|  <b>SNC-LAVALIN</b><br>Wiebe Forest | DESIGN  | JP         | LAKE LOUISE COMPOUND HEATING<br>AND VENTILATION SYSTEM UPGRADE | SCALE                                  | 1:100     |
|  | DRAWN   | TB         |  | PARTIAL FIRST FLOOR ELECTRICAL<br>PLAN | SKETCH NO |

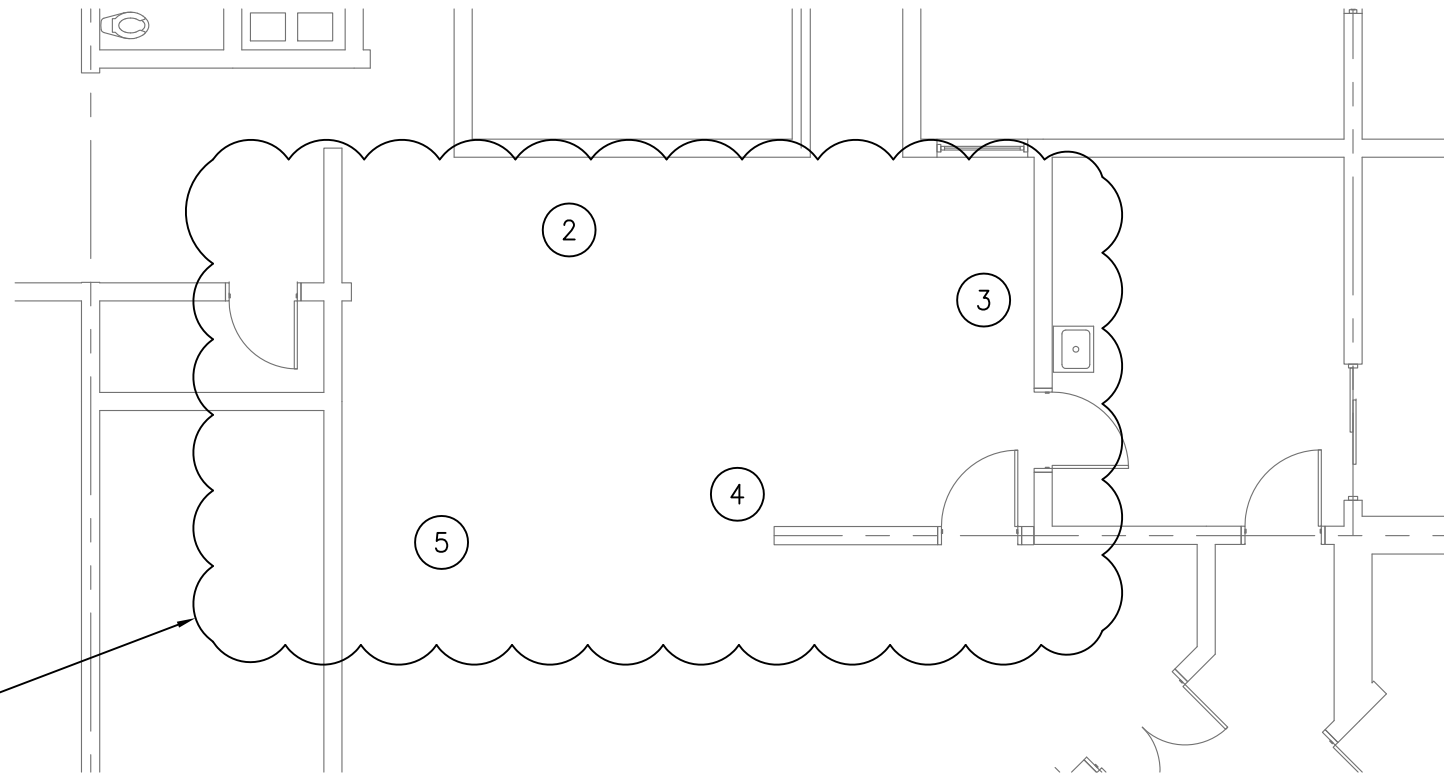
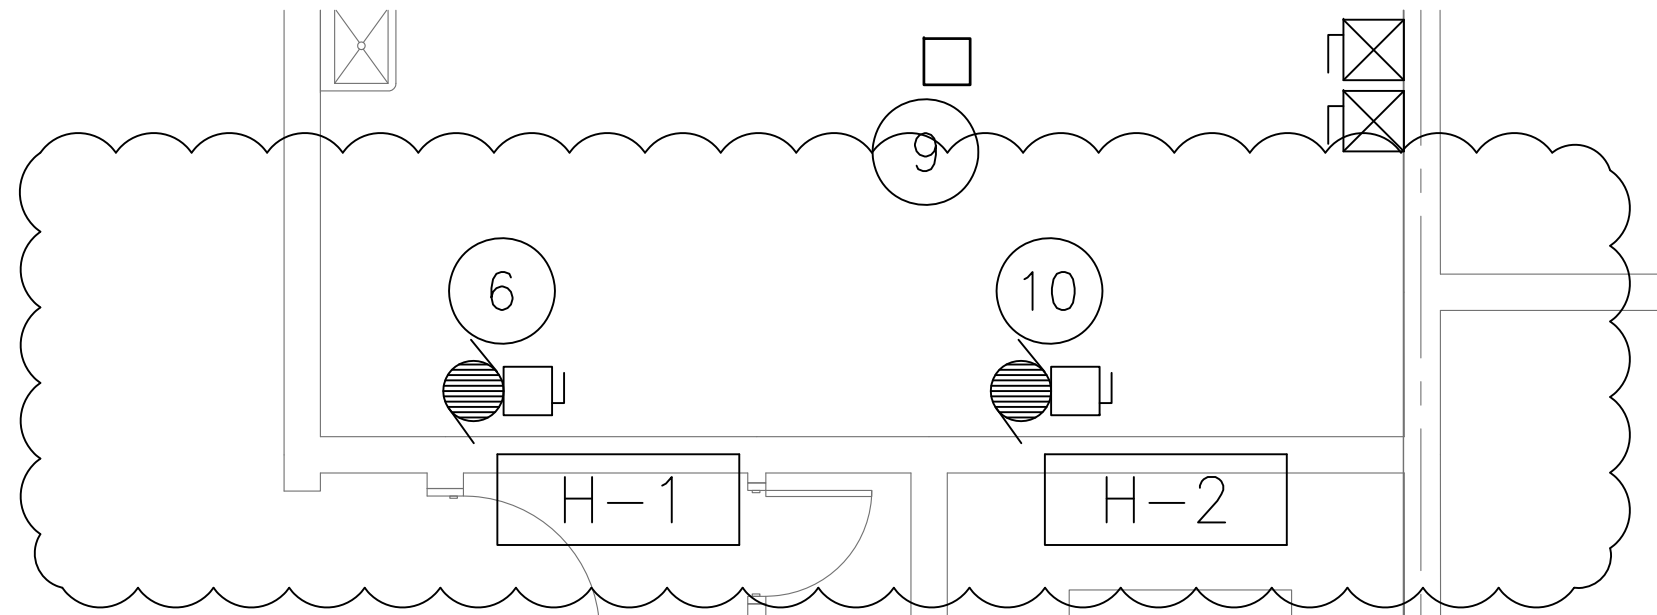
LINE VOLTAGE SOLENOID VALVES REMOVED

REMOVE KEY NOTES 2-5 FROM SCOPE OF WORK
